APC Volume SE SC SW W AR IN USGS Quad Adak C-26241

Anadromous Water Catalog Number of Waterway 306-50-11200

Addition _____ Deletion _____ Correction X Backup Information _____

ALASKA DEPT. OF FISH & GAME
HABITAT AND RESTORATION DIVISION

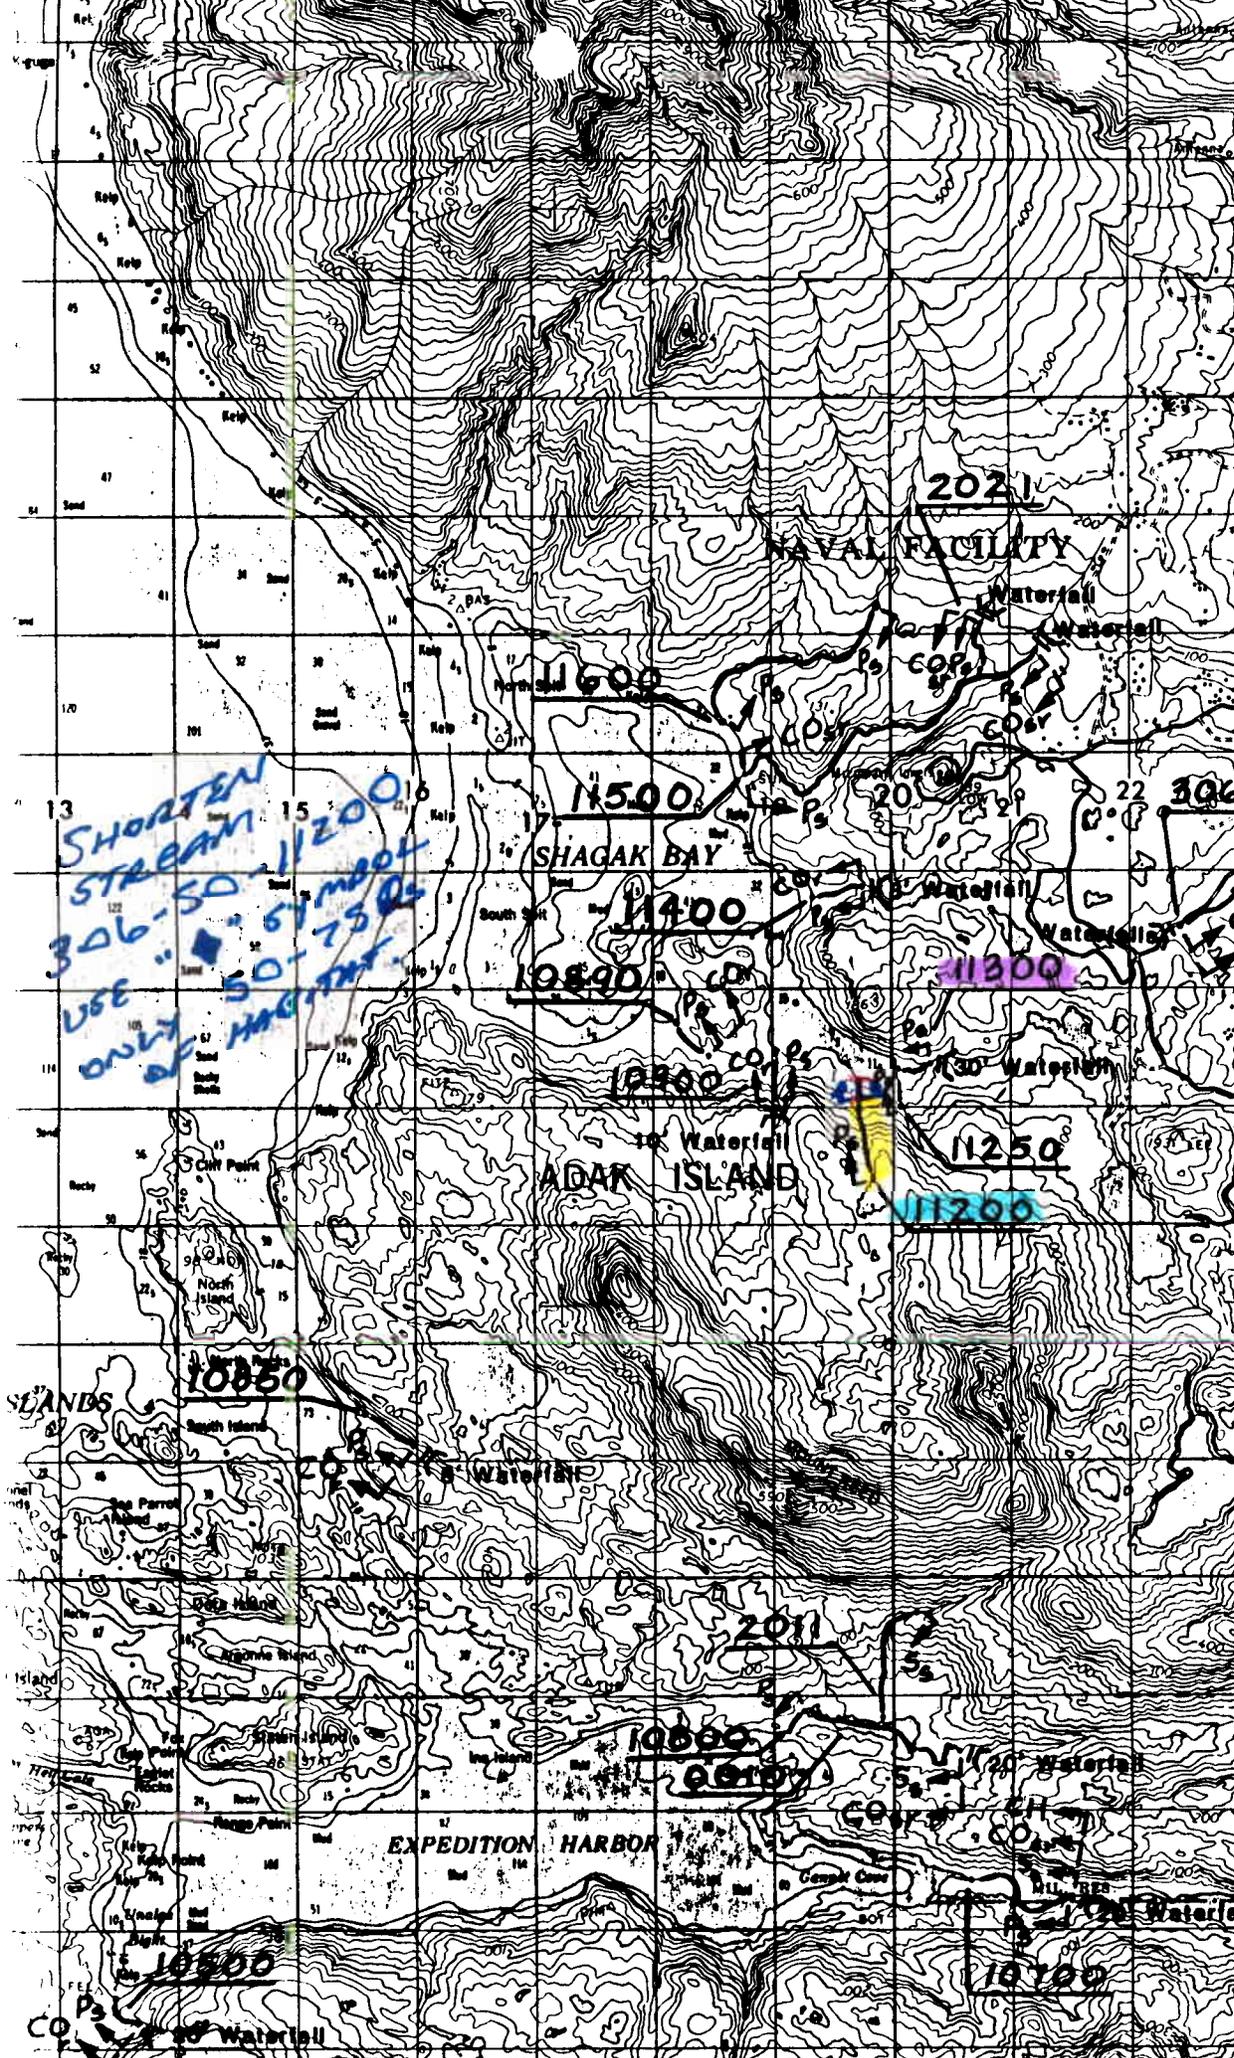
Comments: This stream has only 75' of stream accessible to salmon. none were located on our surveys.

SHORTEN PER THIS INFO AND ORIGINAL NOMINATION WHICH DOCUMENTED 36 FISH & ONLY 50 YARDS OF HABITAT (GALLIS, HOLMES 83) EDW 12/7/94

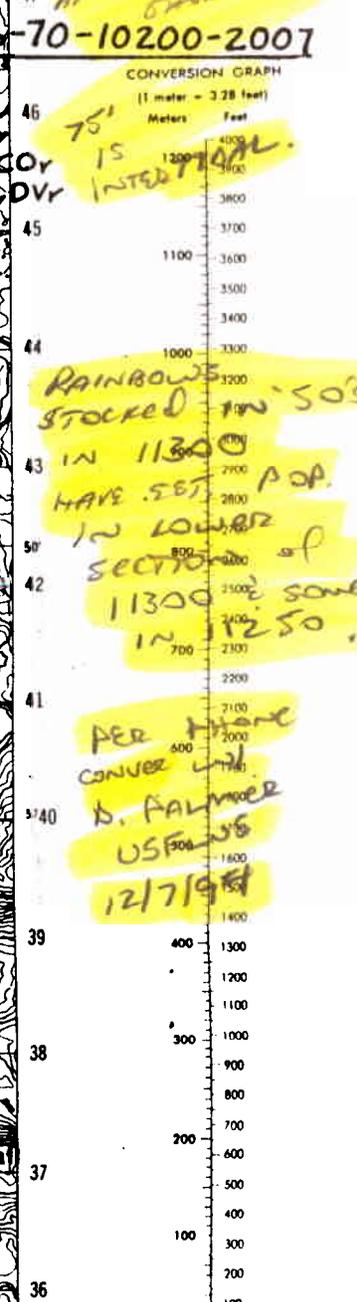
NOT MUCH OF
 STEEP BANKS
 SMALL VOLUMES
 OF H₂O
 CERTAINLY LESS
 THAN 6601 OF
 HABITAT.
 IF IT WAS HIM
 H₂O BELT
 JUST TRICKLE OF
 WATER.
 AT VERY LEAST
 CHARTER

SHORTEN
 STREAM
 306-50-11200
 USE "51" 51 M²
 ONLY OF HABITAT
